**FILE:** X020922.016 **DATE:** 14 May 2021

**SUBJECT:** Information Relevant To Item 7.7 – Project Scope - Pitt Street North Walking and Cycling Improvements

**Attachment A.** Sketch of Eastern Side Cycleway Configuration

## **Sketch of Eastern Side Cycleway Configuration**

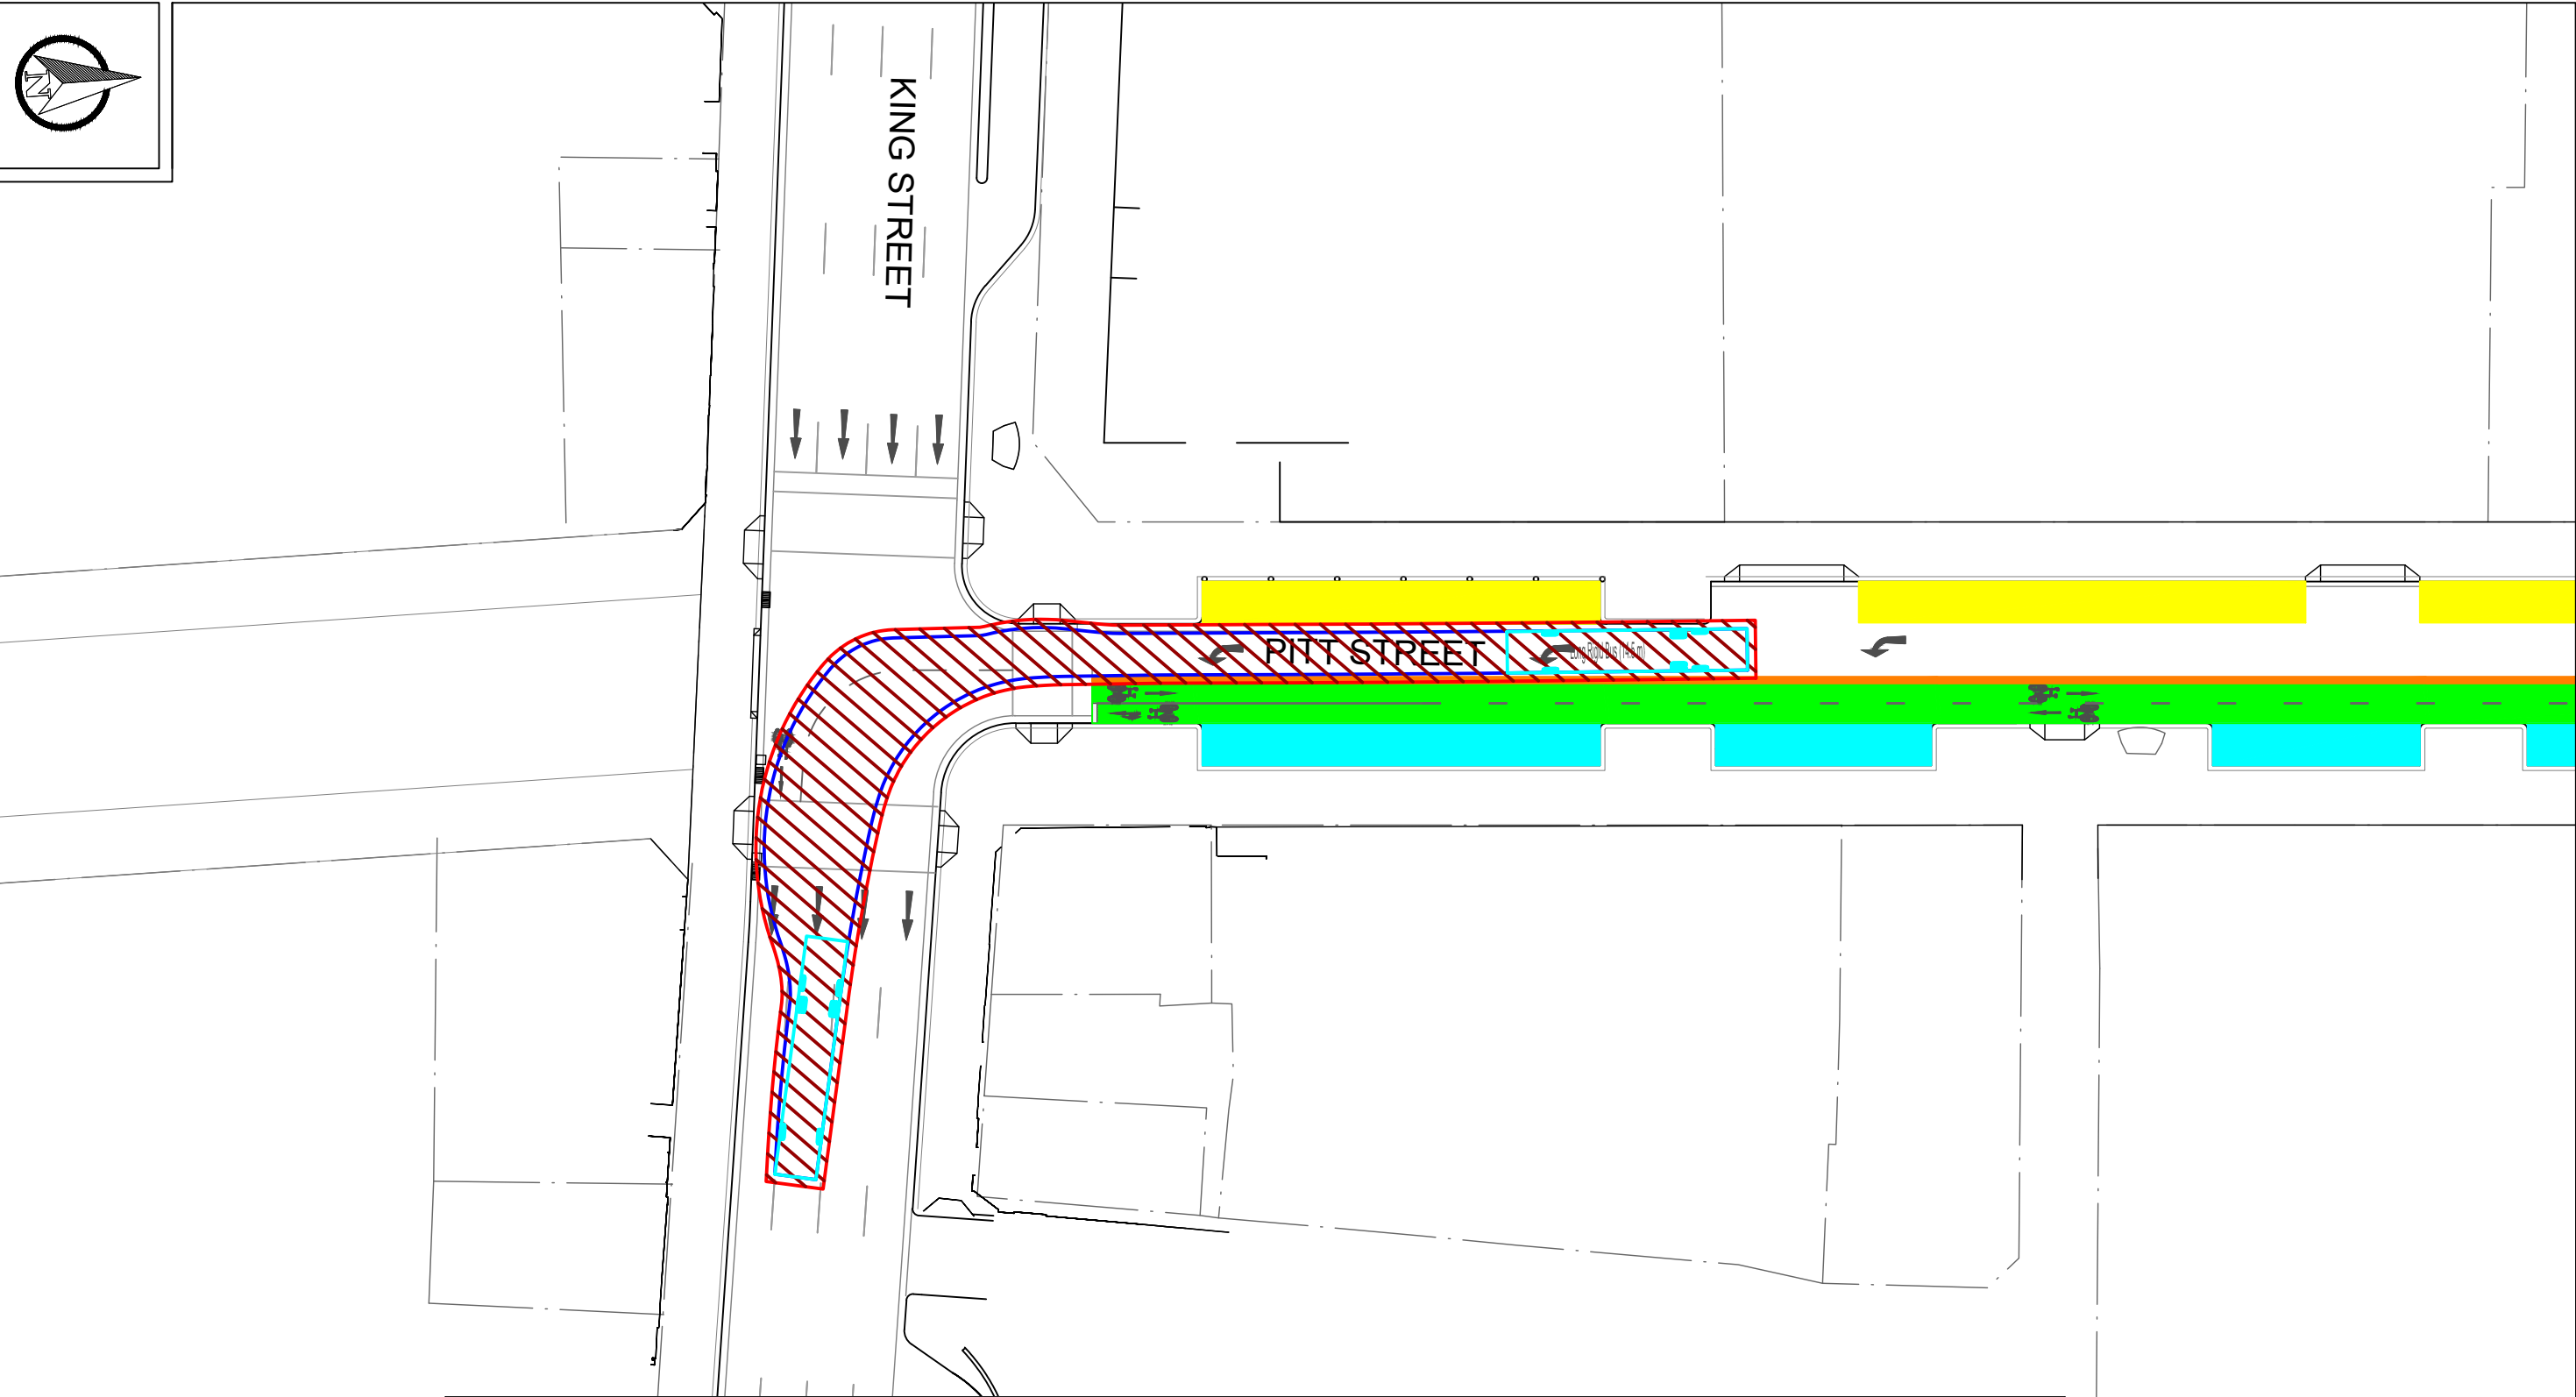
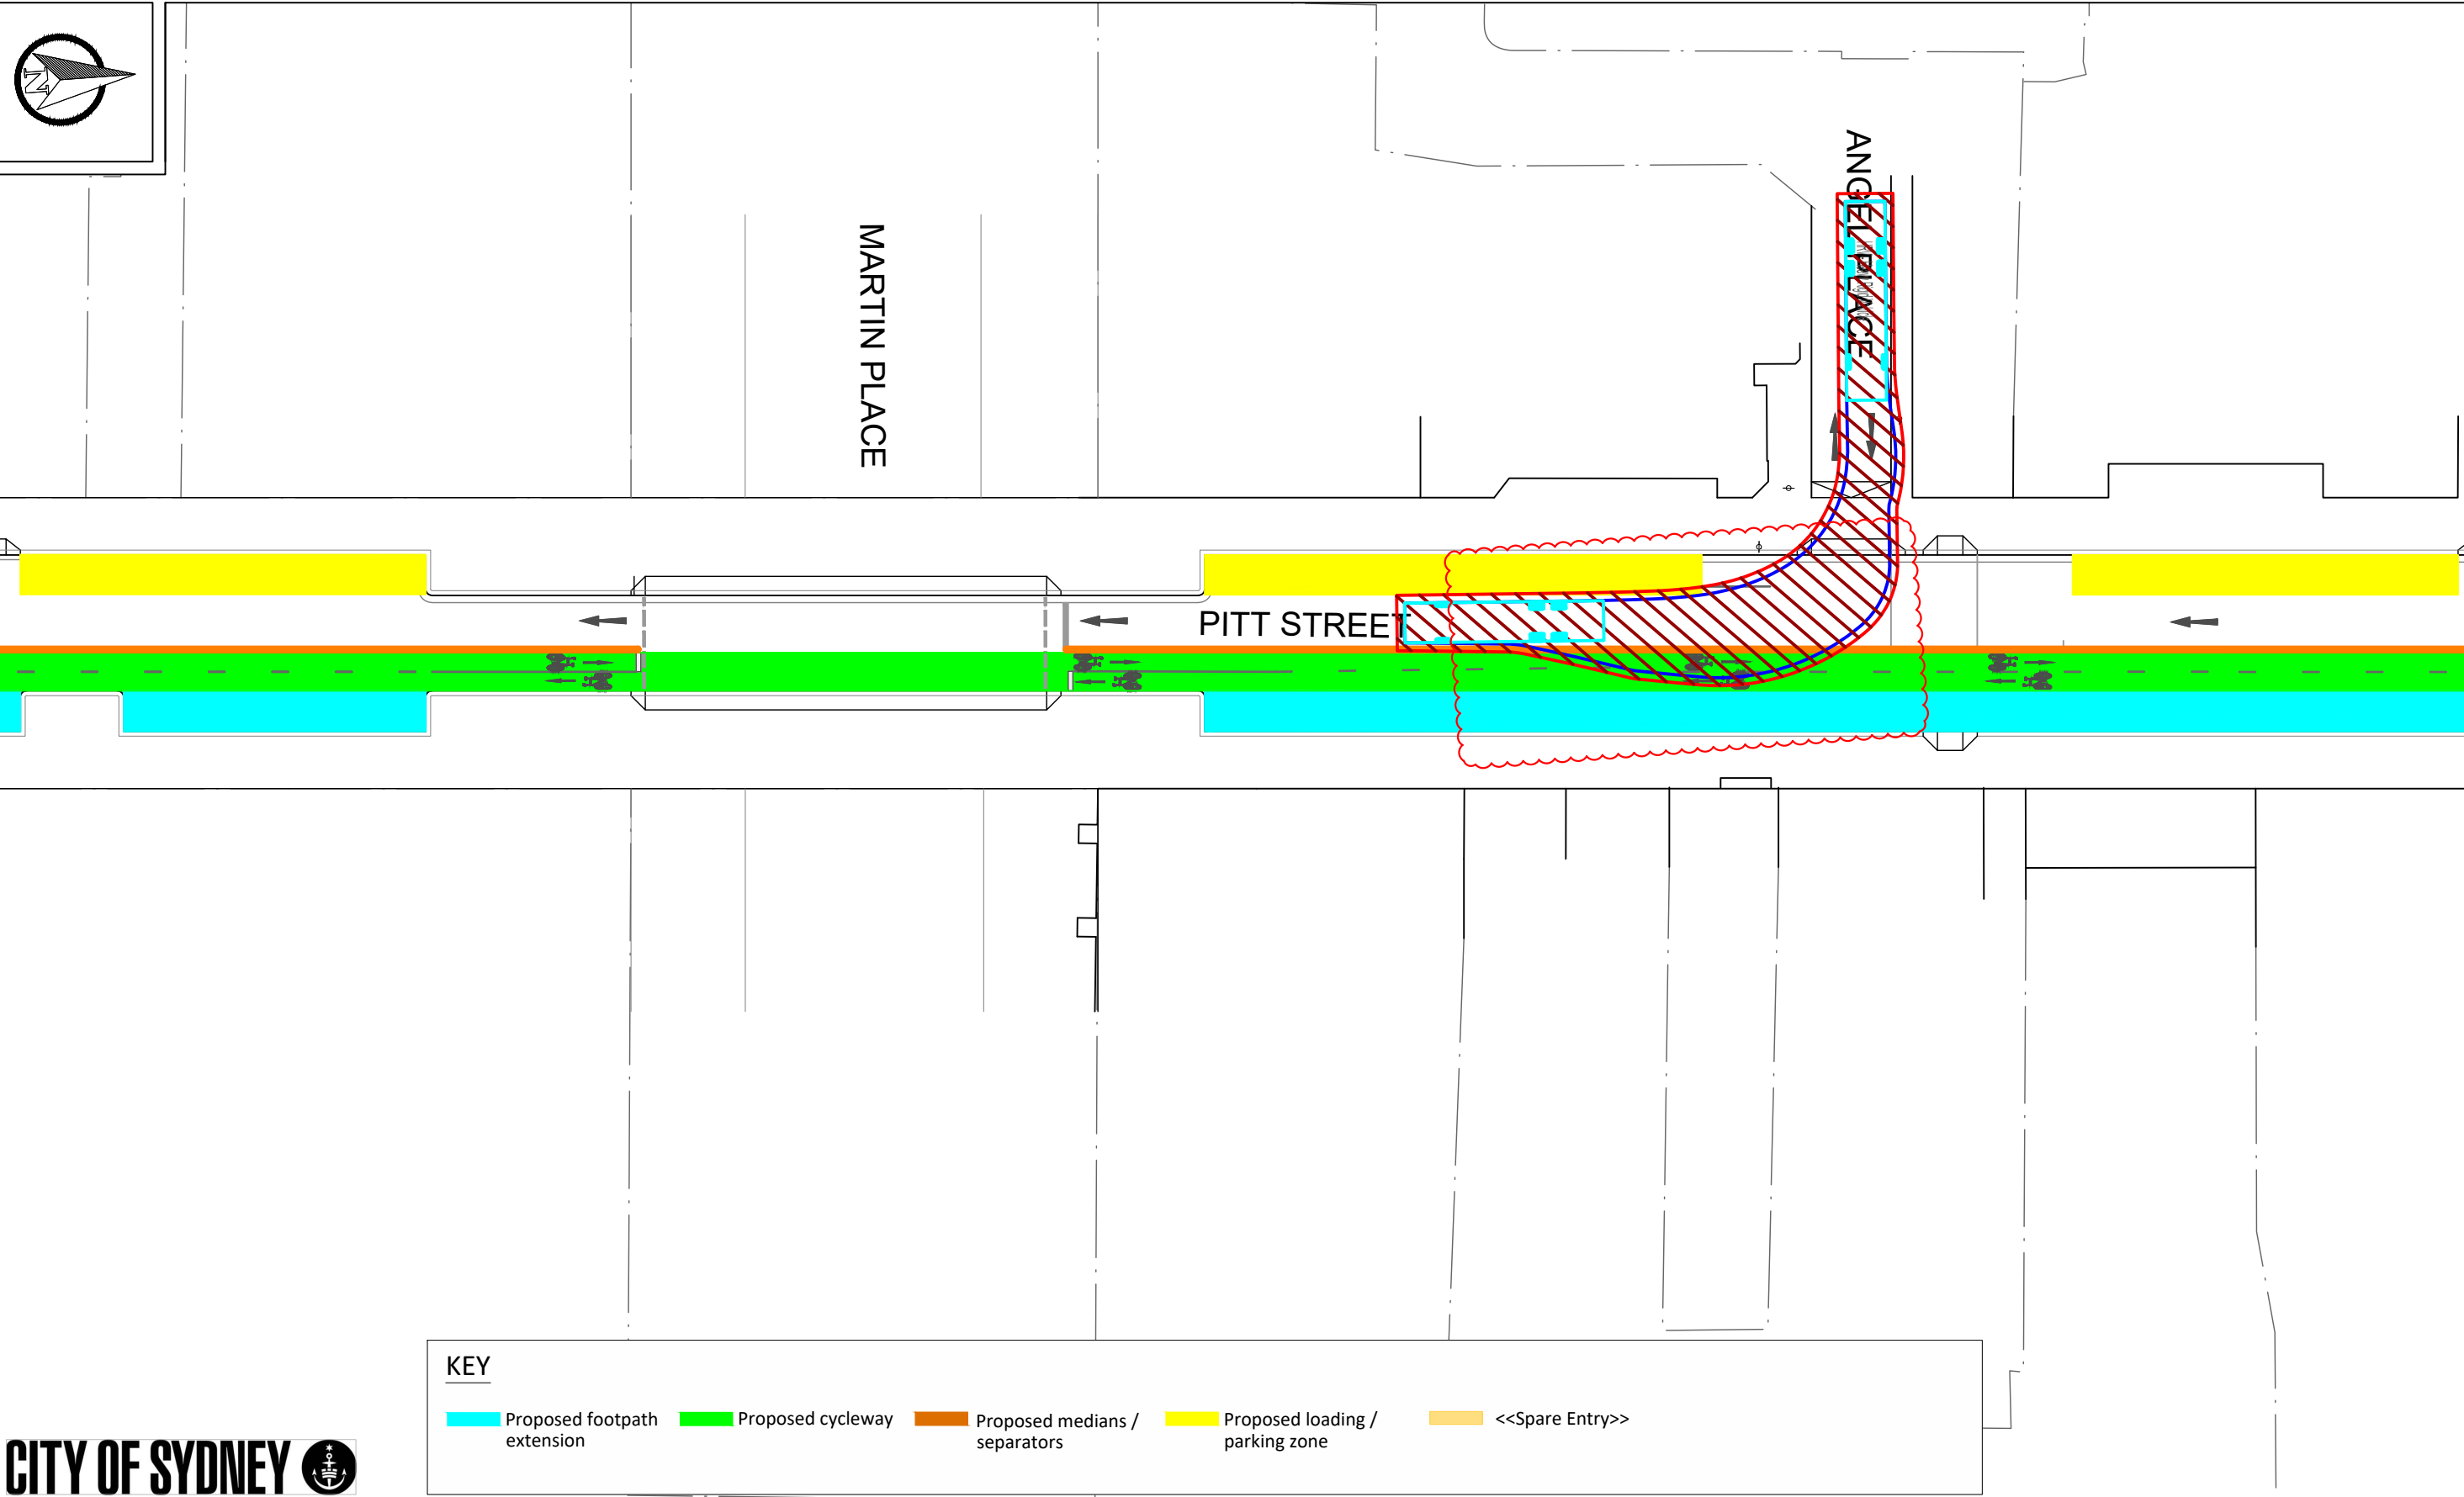
The Urbis submission requests the cycleway be moved to the eastern side of Pitt Street. Their primary contention is that the commercial car park driveways present a safety hazard to people riding when drivers exiting/entering car parks fail to look for bicycle riders. They also raised the following issues: cars queueing across the cycleway, misuse of the cycleway, pedestrian safety, delays in delivery times for businesses, unattractive materials, pedestrians crossing near Bond Street, and lack of bicycle parking.

The City has quickly prepared sketches of a configuration of the road space with an eastern side cycleway. This includes relocating the extra pedestrian area from the western side to the eastern side, and moving the parking on the eastern side to the western side (see Attachment A).

City staff, after reviewing the options again, recommend the cycleway should stay on the western side for road safety and efficiency of transport movement, as recommended in the original report to Committee.
